## **Suffolk County Council**

**Response to the Targeted Consultation 2025**

**Norwich to Tilbury (EN020027)**

Targeted Consultation

**SUFFOLK LOCATION REFERENCE 5  
 FOR TARGETED CONSULTATION 2025  
 COMPARED WITH STATUTORY CONSULTATION  
 2024**

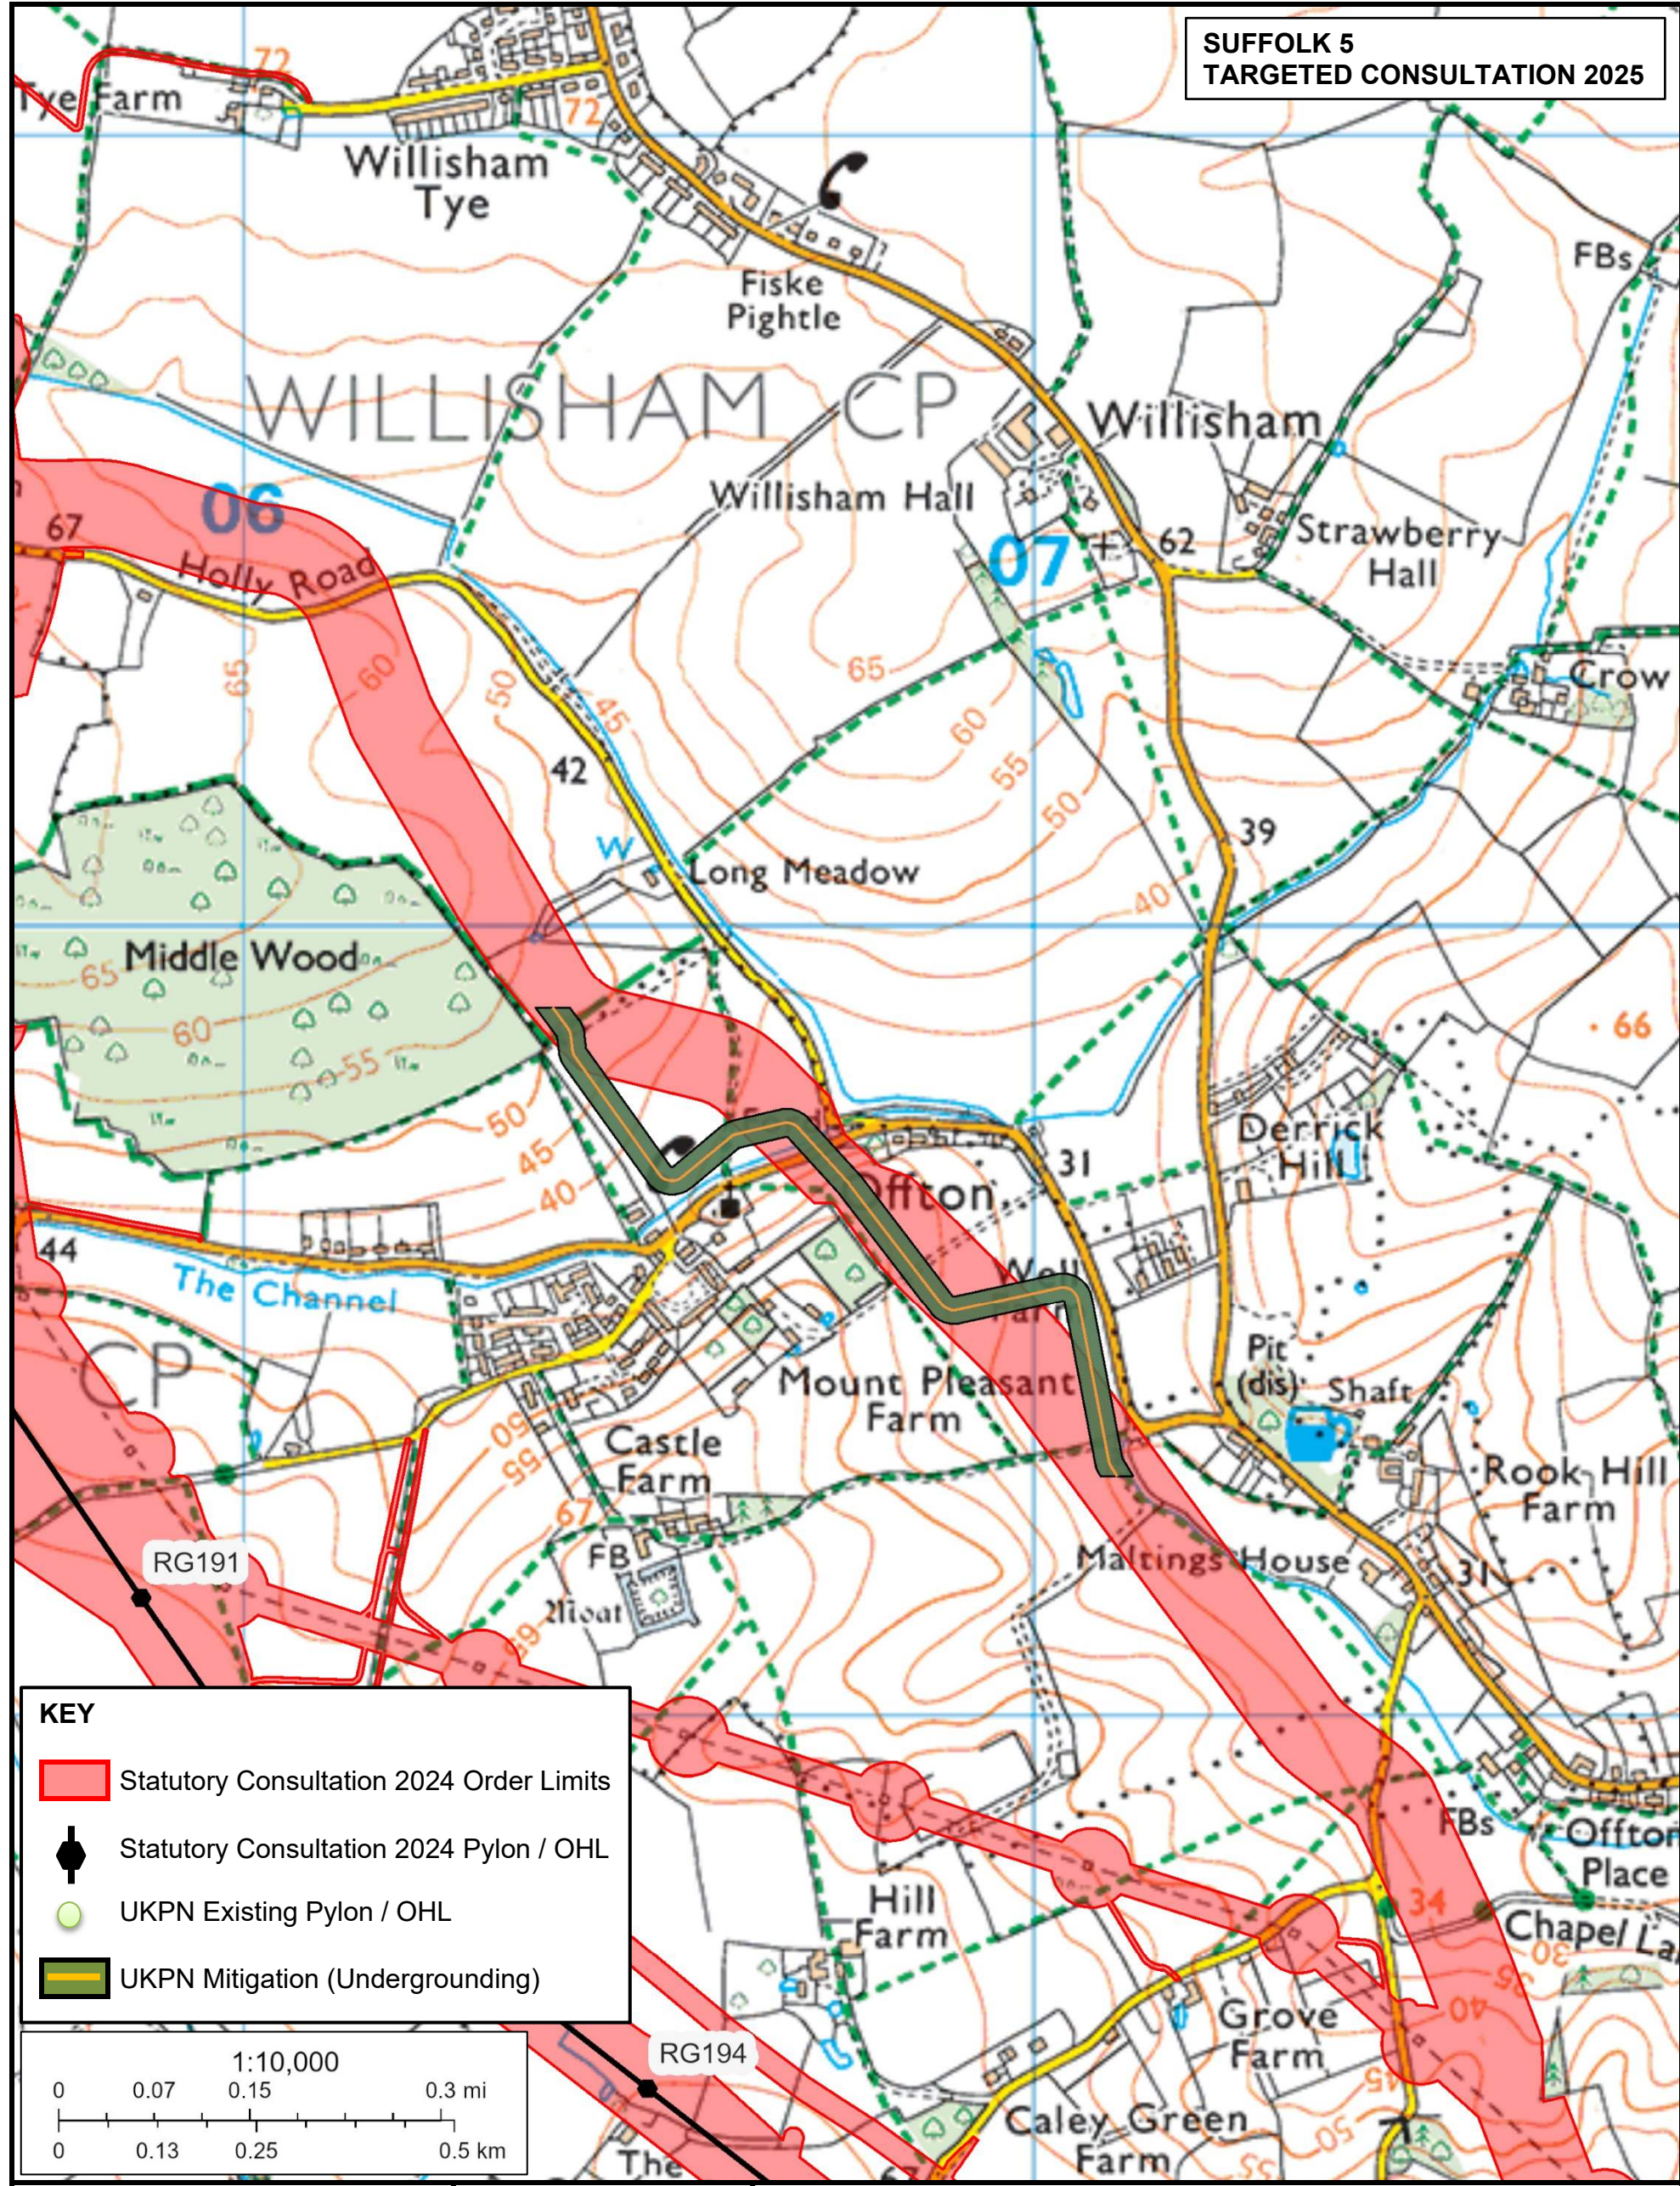
- 2.25. In brief, SCC understands that the proposal at this location is to reposition the route for 132kV underground cables near Offton.
- 2.26. SCC welcomes the proposed change, in principle, as it would reduce impacts on agricultural activity and avoid fields otherwise unaffected by works.
- 2.27. The potential for fewer effects on ecological features is also welcome.
- 2.28. The undergrounding of the UKPN 132kV cable would be in closer proximity to the medieval Grade I listed St Mary’s Church (OFF 005). The Historic Environment section should acknowledge the potential to encounter as yet unknown archaeological heritage assets and that the works involved with undergrounding the 132kV line will damage or destroy archaeological heritage assets.
- 2.29. There are no changes to PROW.

- 4.20. The undergrounding of the UKPN 132kV cable would be in closer proximity to the medieval Grade I listed St Mary's Church (OFF 005). The Historic Environment section should acknowledge the potential to encounter as yet unknown archaeological heritage assets and that the works involved with undergrounding the 132kV line will damage or destroy archaeological heritage assets.

- 4.21. Additionally, undergrounding of the 132kV has the potential to cause changes to groundwater levels, which could lead to the de-watering of important archaeology, such as preserved organic remains, peat deposits and organic silt deposits which may exist. There should be provision to assess these impacts.
- 4.22. Comments on setting and impacts of the construction works (e.g. vibration, dust etc.) upon St Mary's Church should be sought from Historic England and the Babergh and Mid Suffolk District Councils' Heritage officer.

- 5.12. Fewer effects on ecological features are welcome.
- 5.13. It must be ensured that surveys have previously covered or will cover any new “field boundaries” facing impacts during these works and that they have been/will be comprehensively assessed with regard to potential impacts on

important habitats and species associated with these features e.g. arable margins and hedgerows. Otherwise, SCC Ecology concur with the assertion that there will be no change in effects.

- 8.7. The highway authority has no comments on the routing other than access via Bildeston Road or Holly Road is problematic due to their narrow width and the latter being susceptible to flooding (being a ford).

- 9.24. SCC Landscape welcomes the proposed change, in principle, as it would reduce impacts on agricultural activity and avoid fields otherwise unaffected by works.
- 9.25. SCC disagrees with the statement that any visual effect would be temporary, as trees would not be able to be replanted within the cable corridor, which would lead to a permanent visual change.
- 9.26. The provided maps do not show the full length of the cable route corridor for the undergrounding of the 132kV power line. It is therefore not possible to provide comments for most of the route. SCC considers that vegetation losses should be avoided and reduced as far as possible, even if this would require slightly more land take.

**SUFFOLK 6  
TARGETED CONSULTATION 2025**

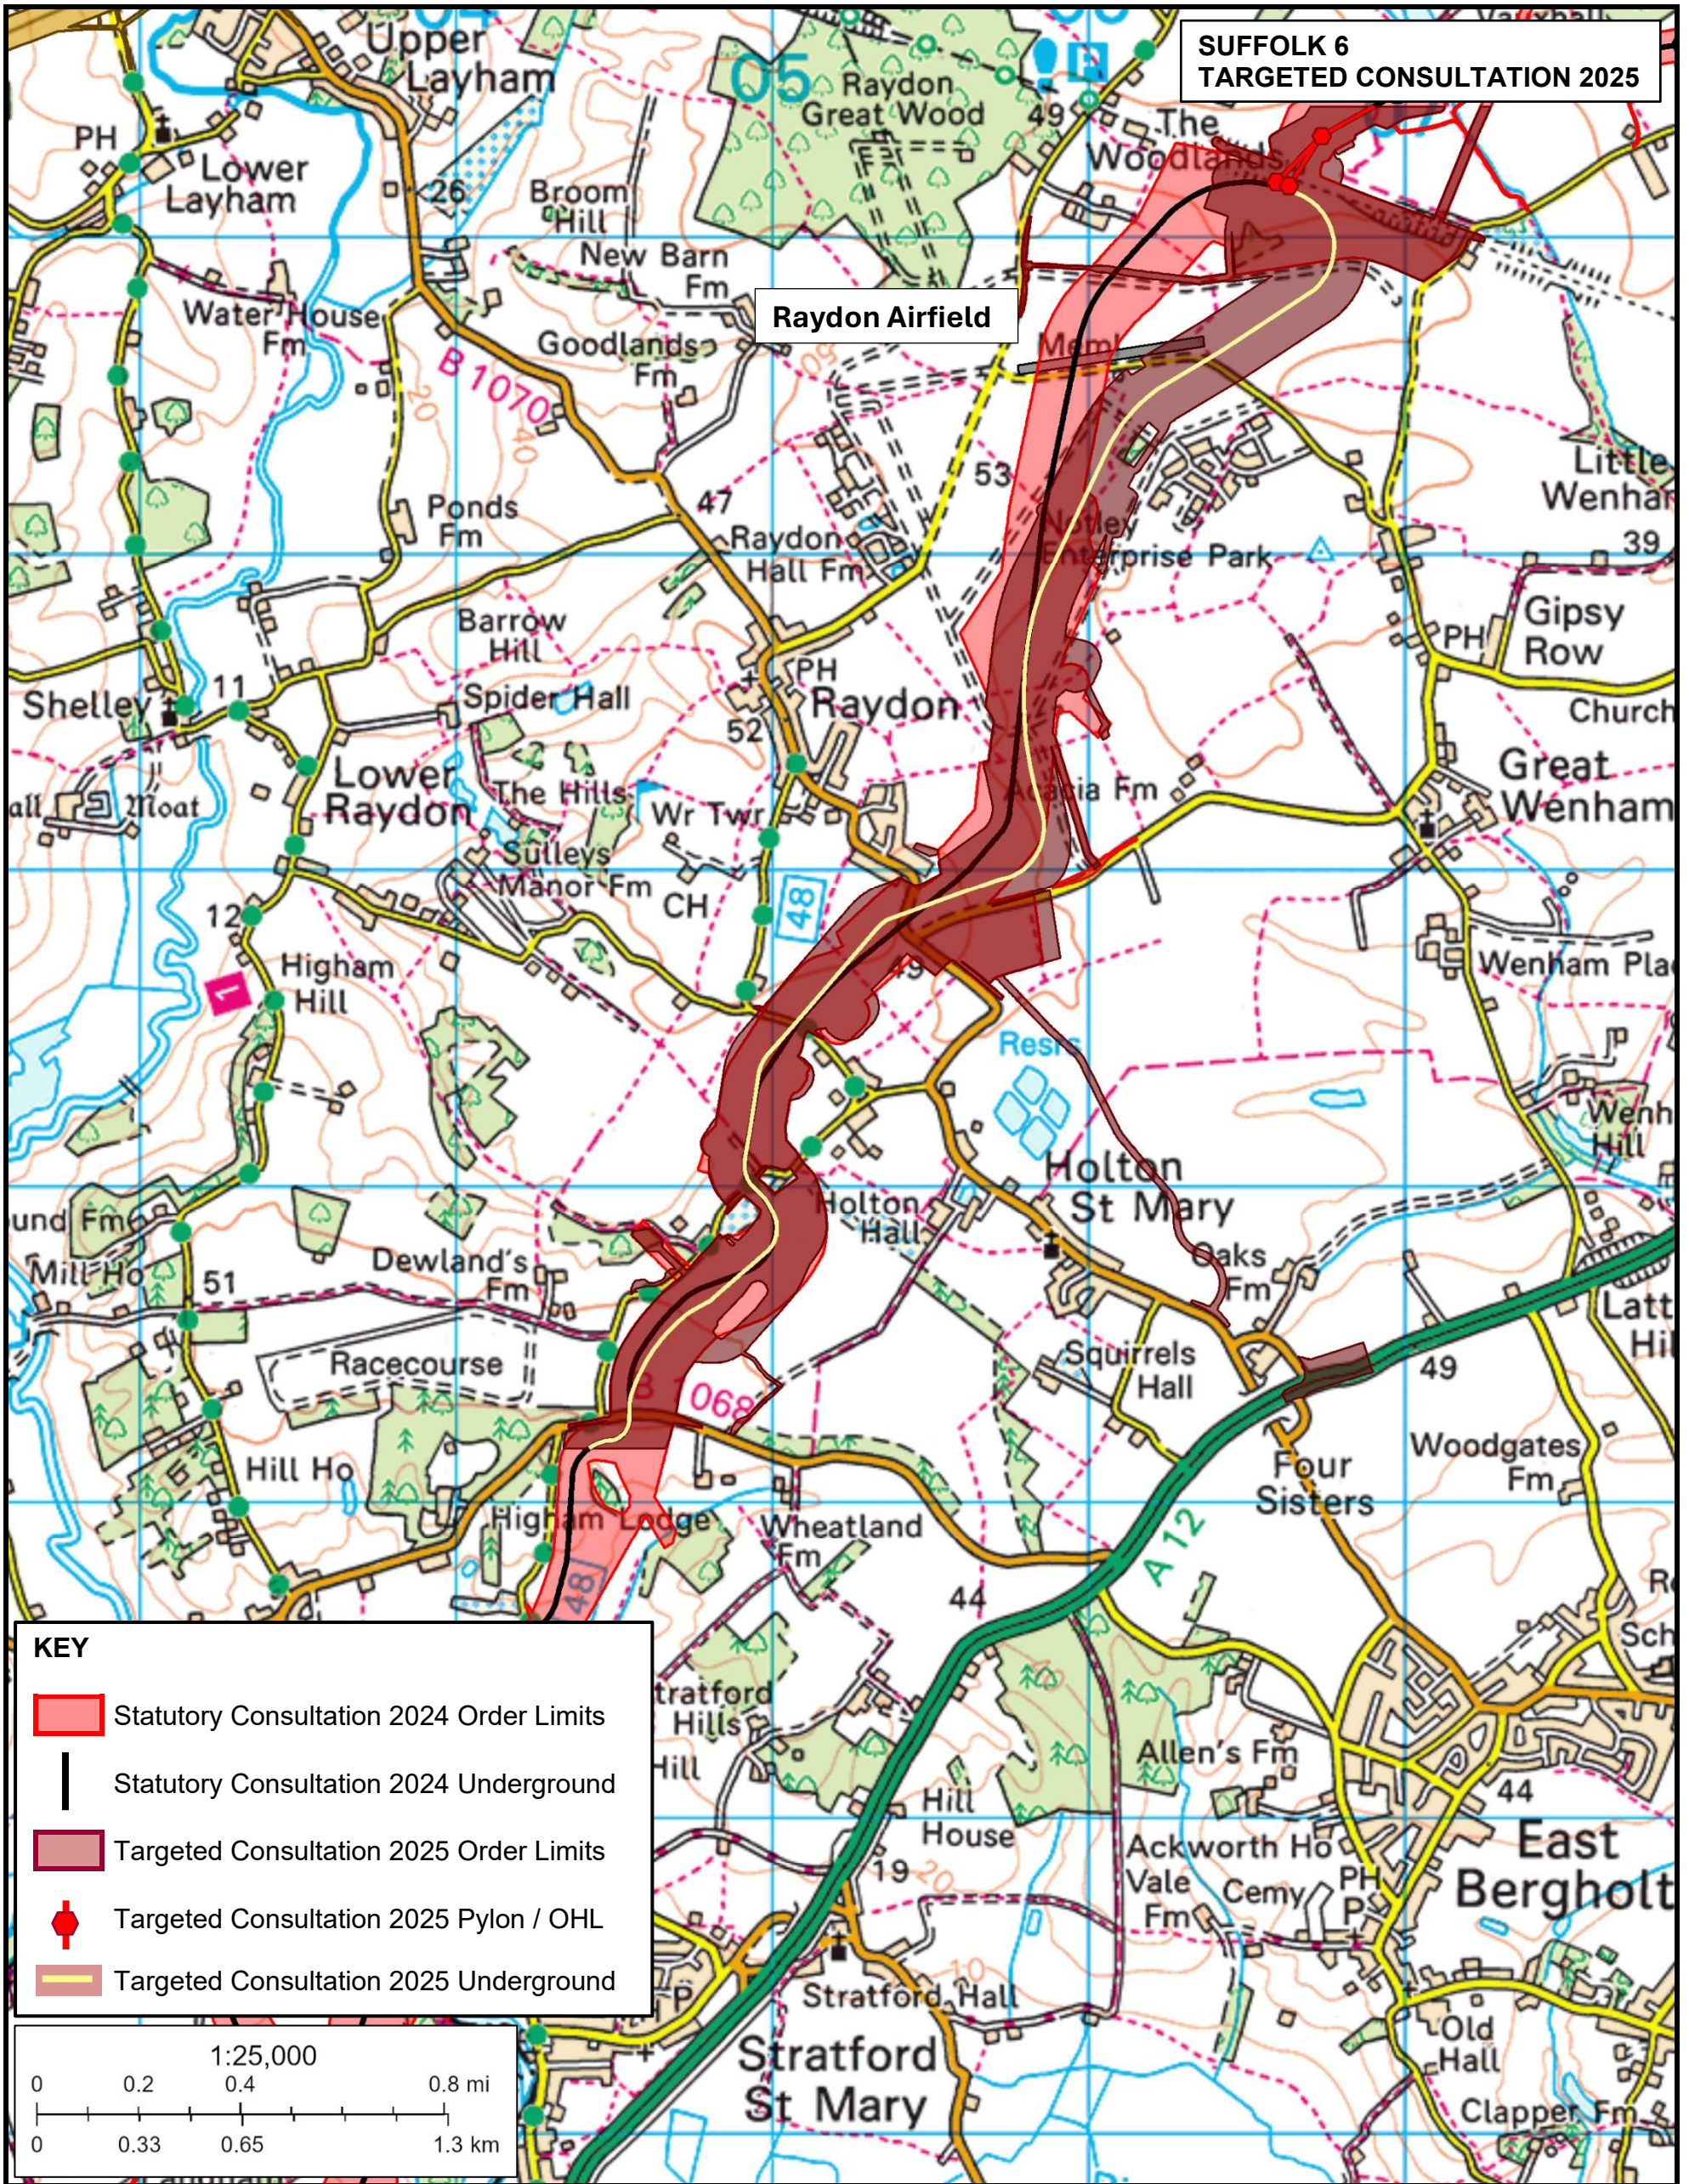
- 2.30. In brief, SCC understands that the proposal at this location is to reposition the underground cable alignment near Raydon.
- 2.31. SCC welcomes the proposed change to the cable route, in principle, as it would lessen the impact on agricultural activity by reducing the number of fields affected by construction.

- 2.32. However, it must be ensured that surveys have previously covered or will cover any new field boundaries and the proposed new bellmouth, facing impacts during these works and that they have been/will be comprehensively assessed with regard to potential impacts on important habitats and species associated with these features e.g. arable margins and hedgerows. Otherwise, SCC concur with the assertion that there will be no change in effects.

- 2.33. SCCAS welcome the acknowledgement of the proposal affecting as yet unknown archaeology.
- 2.34. There are no changes to PROW.

- 4.23. SCCAS welcome the acknowledgement of the proposal affecting as yet unknown archaeology.
- 4.24. If the changes for this section are adopted, the changes should be included within the pre-submission archaeological evaluation written scheme of investigation.

- 5.14. It must be ensured that surveys have previously covered or will cover any new field boundaries and the proposed new bellmouth, facing impacts during these works and that they have been/will be comprehensively assessed with regard to potential impacts on important habitats and species associated with these features e.g. arable margins and hedgerows. Otherwise, SCC Ecology concur with the assertion that there will be no change in effects.

- 8.8. From a highway perspective, SCC welcomes the proposal of a temporary haul road to remove construction traffic from passing through Holton St Mary. However, SCC would seek reassurance that the order limits are sufficient to provide a safe access to the B1070 and that space for drainage of the haul road has been considered.
- 8.9. SCC would seek clarity regarding the additional area adjacent to the A12/B1070. Is this a construction compound or does it allow for improvements to the slip road onto the A12?

- 9.27. SCC Landscape welcomes the proposed change to the cable route, in principle, as it would lessen the impact on agricultural activity by reducing the number of fields affected by construction. The additional loss in vegetation would need to be fully assessed, however.

- 9.28. From a landscape perspective more difficult to support is the proposed change for an additional haul road to bypass Holton St Mary. The location of the proposed bell mouth appears to cut through a patch of mature vegetation, which is not acceptable. SCC Landscape considers that, if this haul road is required, it would need to be micro-sited to avoid any mature hedgerow trees and Important Hedgerows, and that this must take priority over avoiding arable land in this instance, as the latter would be more easily reinstated.

- 9.29. It is noted that the construction compound at Piper's Went has increased in size and that this has also increased the DCO limits. This change has not been explained.
